FOUNDATION INVESTIGATION REPORT

W.P. 122-61, HIGHWAY 62

FOUNDATION INVESTIGATION REPORT

Re: S.P. 122-61, Highway 62,
Indian River in Alice,
District No. 10, Bazaroft.

SOIL MECHANICS LABORATORY
 CONSOLIDATION TEST

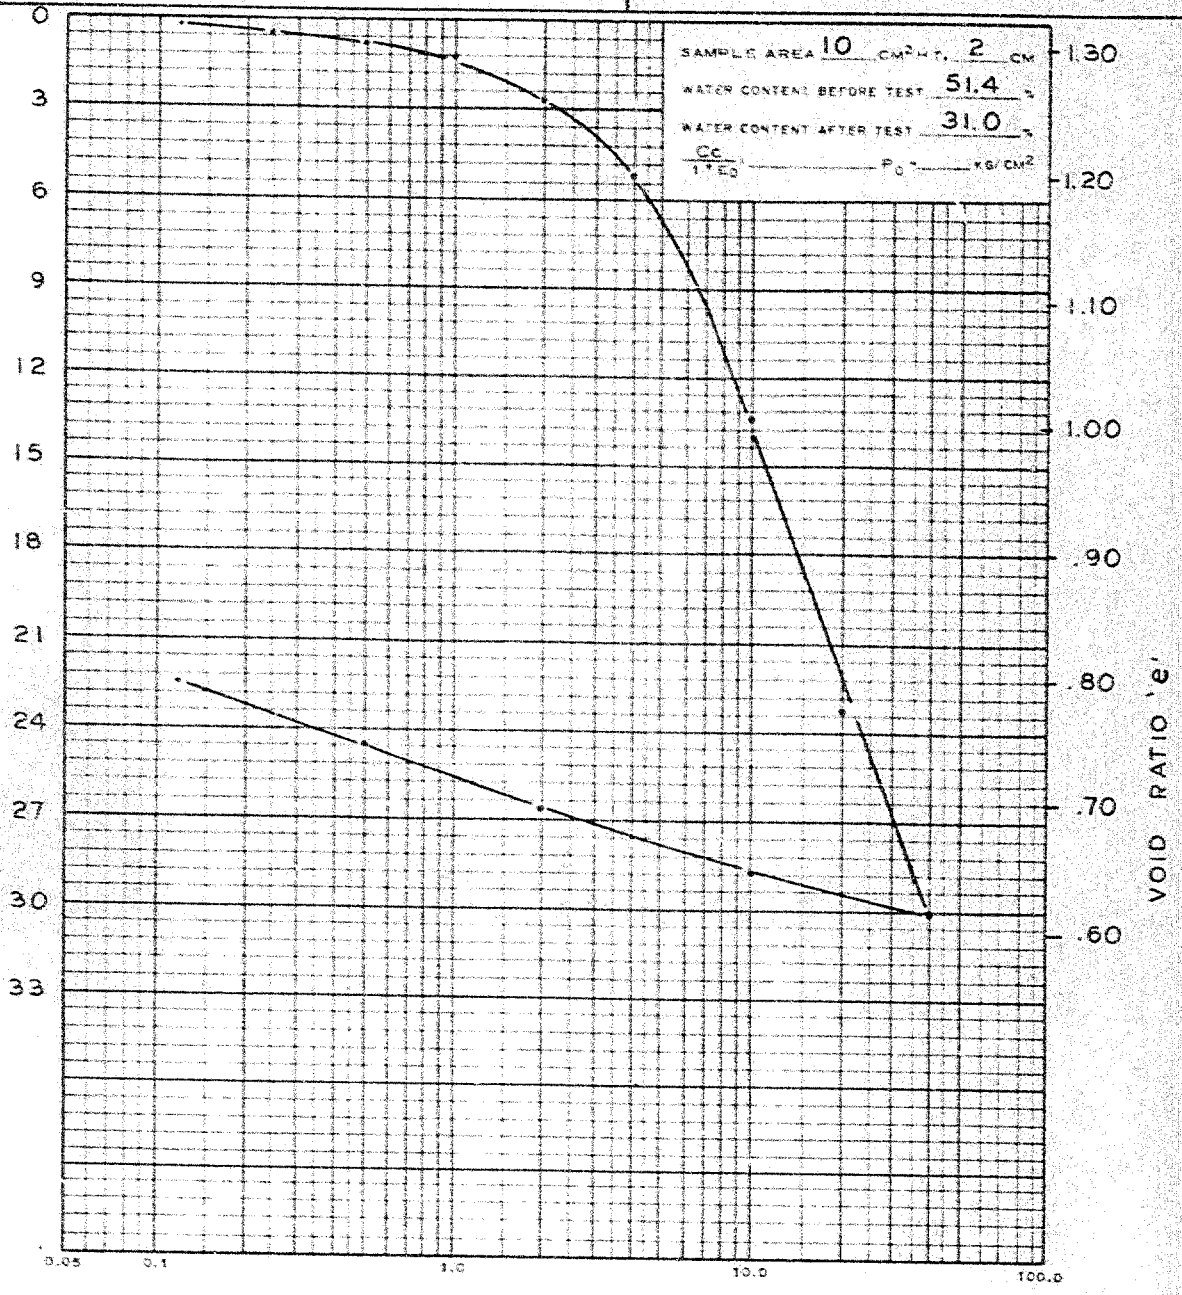
The settlement analysis was carried out on the basis of only one oedometer test. The moisture content of the tested sample is 51.4%, which is higher than any other sample, and can therefore hardly be regarded as representative. The settlement result was not corrected for the discrepancy resulting from the use of oedometer results.

In the light of the above-mentioned facts, it is our opinion that the settlements mentioned in the report can be reduced some 40 to 50%. Since the rate of settlements will be quite slow, we believe that serious consideration can be given to a spread footing design.

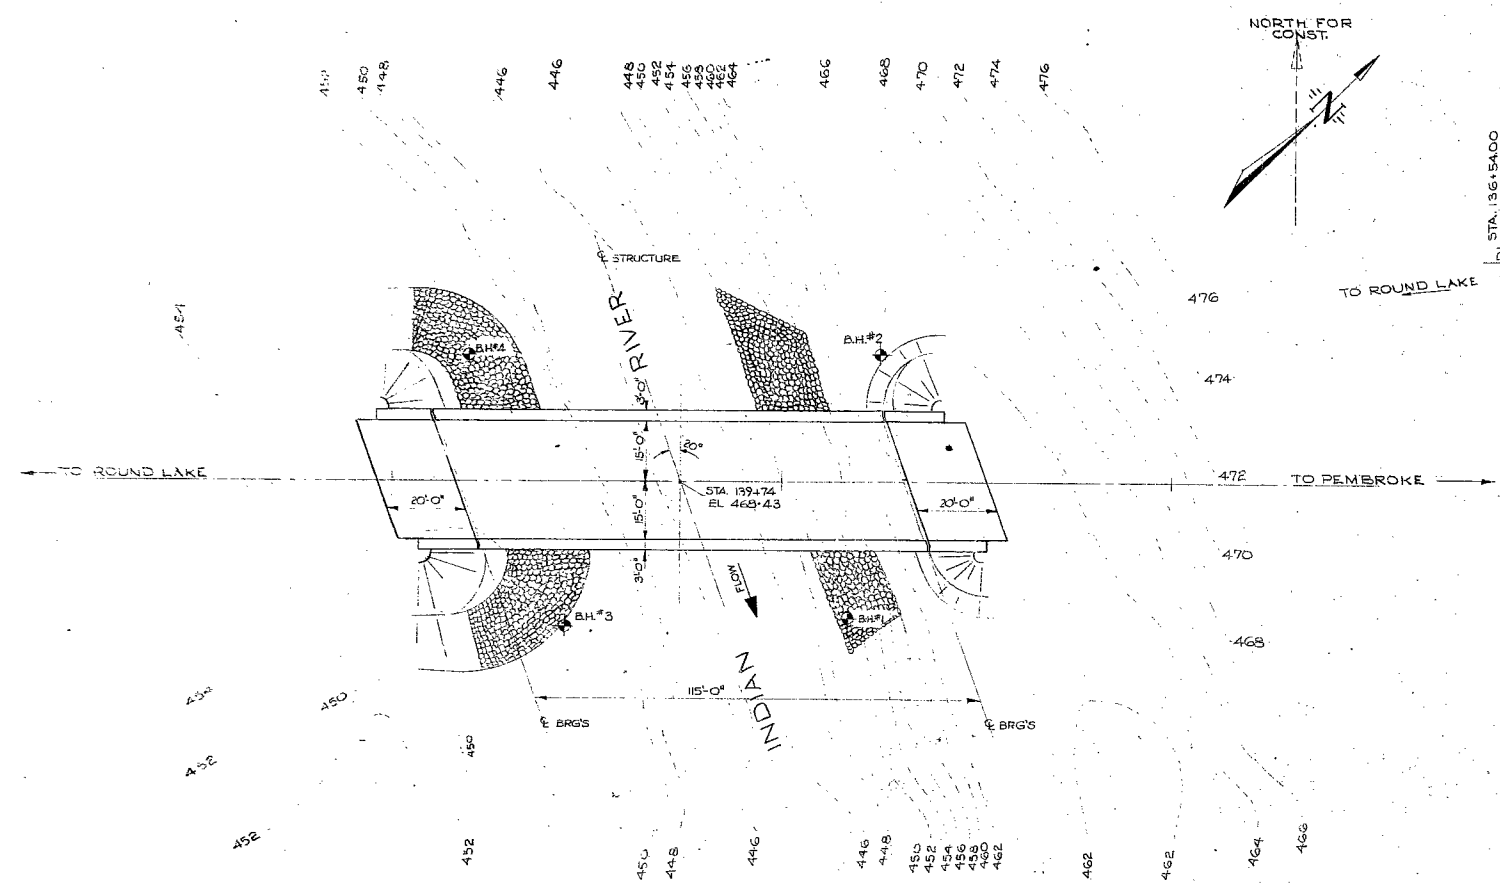
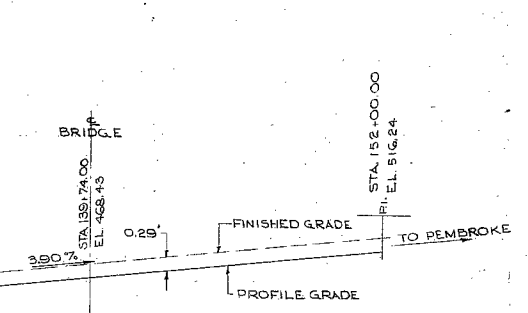
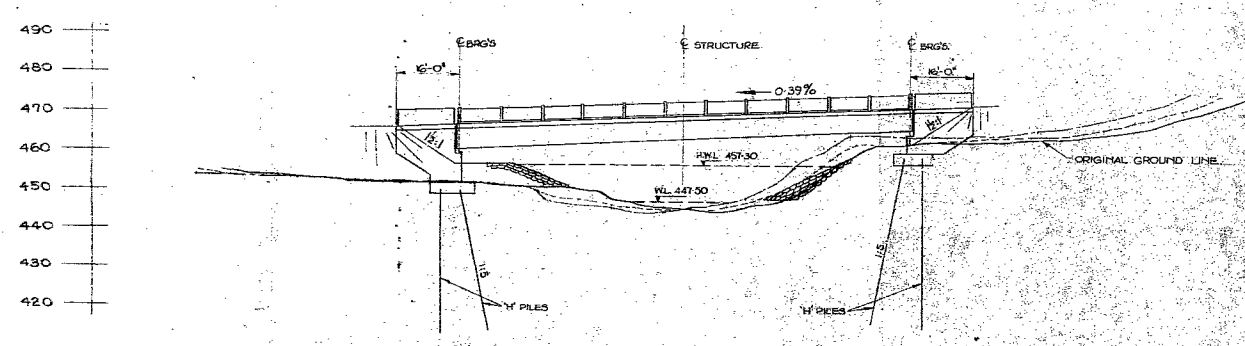
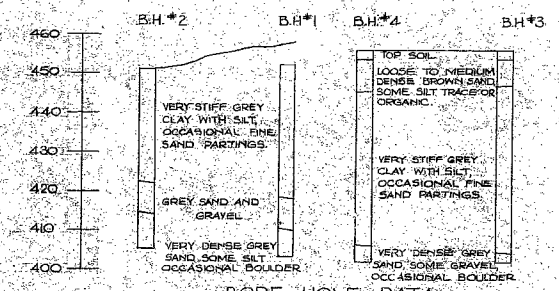
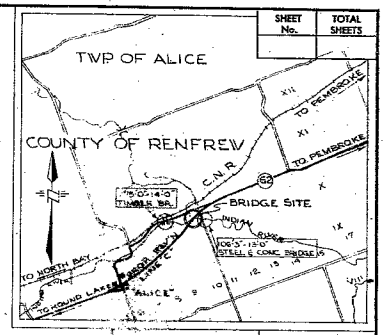
Best foundation is one alternative and if analyses have shown that this solution is the most economical, there are no objections.
April 13, 1966
Aftermore,
